YARRA CITY COUNCIL
Internal Development Approvals Committee
Agenda

**to be held on Wednesday 26 November 2014 at
6.30pm in Meeting Room 3 at the Richmond Town Hall**

137 Queens Parade, Clifton Hill - PLN14/0209

1. This report provides Council with an assessment of a planning permit application submitted for 137 Queens Parade, Clifton Hill, which seeks approval for development of the land for buildings and works consisting of a four storey building, for the use of 18 dwellings and 3 food and drink premises (no permit required use for food and drink premises) and a reduction in the car parking requirement, including demolition of the existing building. The report recommends approval, subject to conditions.

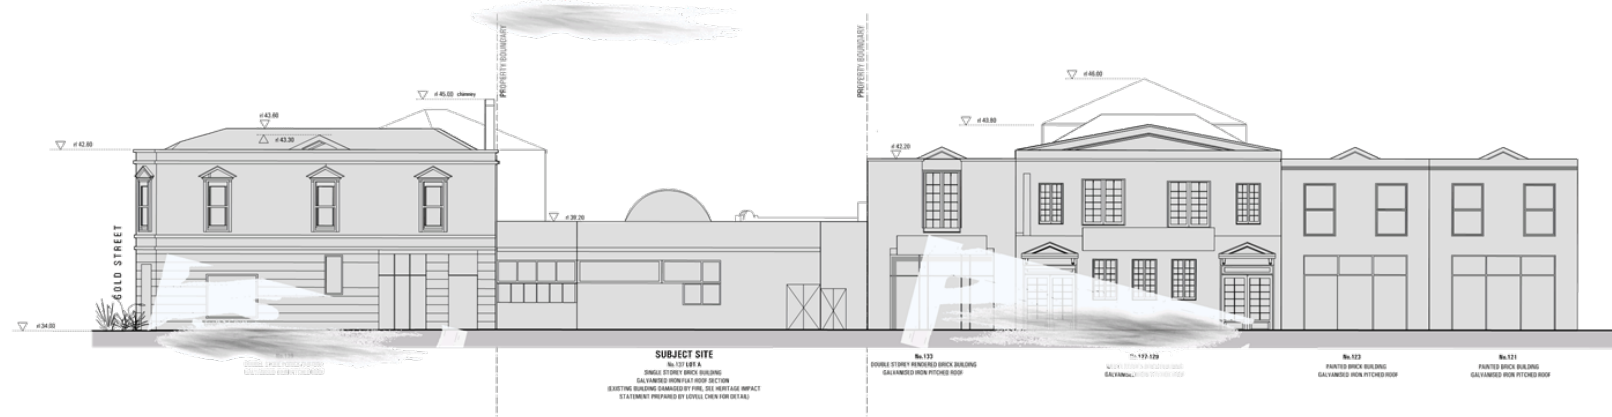
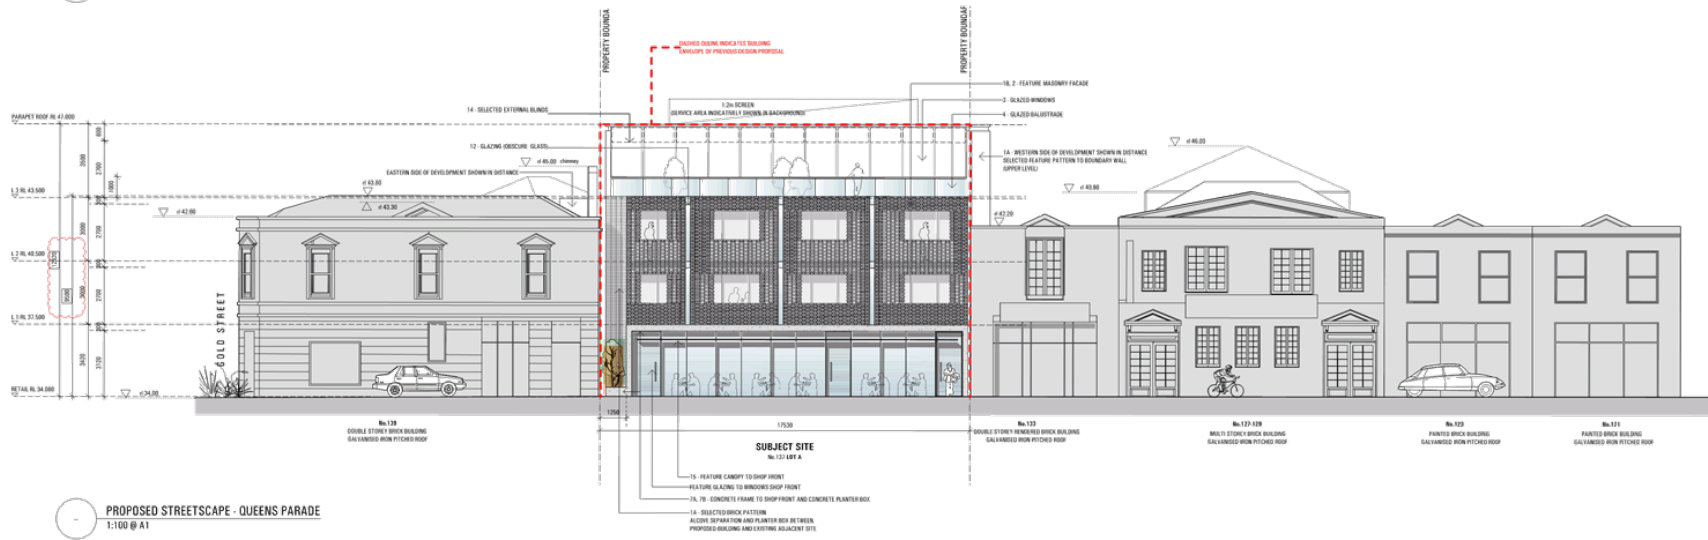
87. *As drawn, the shopfronts along Queens Parade appear to be articulated. They are proposed to have a setback of 600 mm from the property line and with a further recession behind that. Shopfronts in Queens Parade all abut the property line and are all aligned in a single plane. As such the shopfronts are not respectful of "the pattern, rhythm, orientation to the street, spatial characteristics,... and heritage character of the surrounding historic streetscape". There does not appear to be any necessity for this articulated design. Further, shopfronts in Queens Parade overwhelmingly have a solid stallboard (plinth) beneath the window which, inter alia, serves to visually anchor and emphasize the building line. The shopfronts should have zero setback and be aligned in a single plane.*

92. *Rather than having a single composition, the façade at the first and second floors is broken up into four elements which reflects the typical Victorian streetscape pattern and of itself is acceptable. While the horizontally-oriented rectangular openings to the balconies differ from the typical fenestration pattern they are not so unacceptable as to require change.*

95. *The concrete band around the shopfronts and the planter (7A and 7B) are acceptable subject to clarification of the finish – is it to be painted, textured, off-form or something else?*

96. *A “feature canopy” is proposed above the shopfronts and “feature glazing” is proposed for the shopfronts. From the small illustration provided it is impossible to judge exactly what these elements might be and further detail is required.*

97. *Obscure glazing (12) is also proposed between the façade elements at the first and second floors. Similar glazing is proposed for the balustrades (See note on TP 3.11). Again it is impossible to judge the appearance of this glass exactly and further detail is required.*
98. *The external blinds will be minimally visible when extended but would be acceptable subject to colour. A pale neutral colour is preferred.*
99. *Samples of all materials (other than for conventional clear glazing) proposed for either façade are required as any reasonable judgement from small illustrations is impossible.*
100. *Subject to the provision of actual samples of materials proposed, the other materials proposed for this façade are accepted in principle.*

108. *The shopfronts should have zero setback and be aligned in a single plane and have a stallboard (plinth) beneath the window glazing.*
109. *Delete the hit-and-miss/mesh brickwork and substitute a material which is quieter and a more sympathetic and subtle response to the typical render or exposed brickwork of the buildings in Queens Parade.*

110. *Provide further details of the concrete band around the shopfronts, the shopfront glazing and the canopy above, sufficient to be able to gain a clear understanding of their final appearance. Likewise all translucent and obscure glazing.*

214. Regarding the materials of the proposed building, the Queens Parade frontage shows hit and miss brickwork, which is not suitable given the heritage context of the site and the dominance the large combined structure across the first and second floors will produce. It is considered that a more common approach may produce a better heritage outcome, rather than a structure that draws attention away from the heritage streetscape. The front façade will therefore be conditioned to be modified to remove the hit and miss bricks to be replaced with a more sympathetic material (ie. solid or rendered brickwork).

DRAWING TITLE Existing and proposed side elevation (South West)		SCALE 1:100 @ A1	PROJECT 13_03
PROJECT Osmos Pk, Apartments	DATE APRIL 2015	DRAWING 3.05	
CLIENT Elba Investors Holdings 1 Pty Ltd	DESIGNED	DATE PLOTTED 26/11/14	REV A

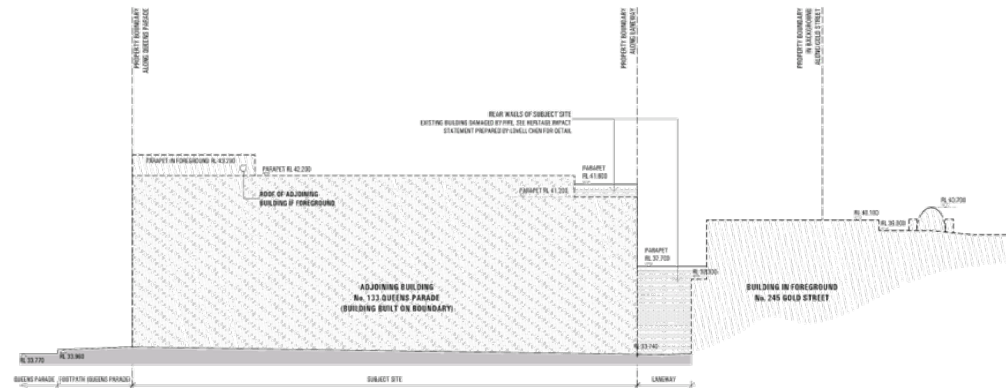
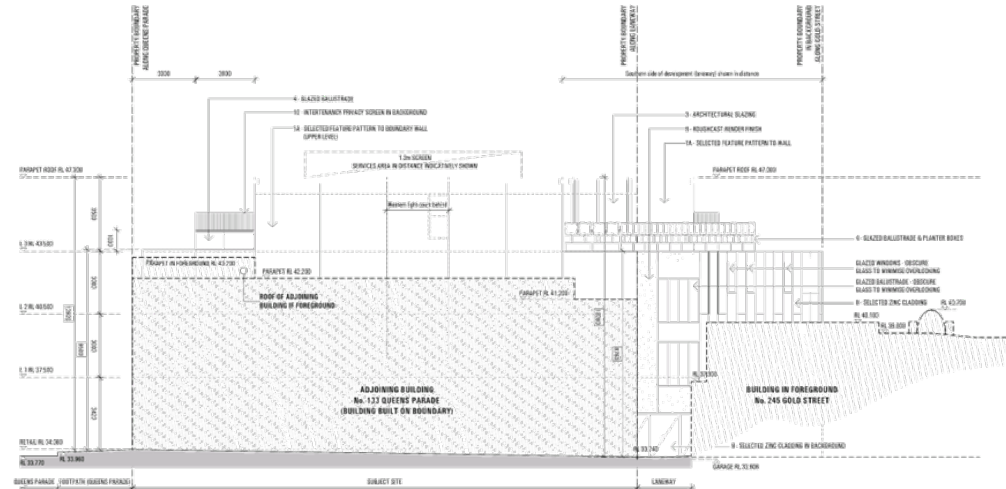
193. The south boundary wall is separated from a residential property on the opposite side of the rear, 3m wide ROW. The wall does not comply with the minimum Rescode setback distance (were the wall constructed setback from the boundary) of 5.05m for a 9.96m high wall. However, the wall is placed opposite a side boundary wall of the neighbouring property, and a small services area at the rear of the site, and separated by the rear laneway. Overshadowing from the proposal will add additional shadowing to the rear services area during morning hours, and is to a relatively small area of private open space at the rear of the lot (as opposed to the main area of open space at the south of the site. As the wall is provided with a setback by association with the rear ROW and has limited amenity impacts, it is considered acceptable and typical of built form outcomes in more densely developed areas.

195. The upper most floor however, has a low glass balustrade, with an external planter box. Overlooking diagrams provided indicate that the south facing, upper balcony will not overlook, but appears to measure views across the top of potential landscaping. A condition will be placed on any permit issued that the rear south-facing balcony to apartment 304, be compliant with the overlooking Standard.
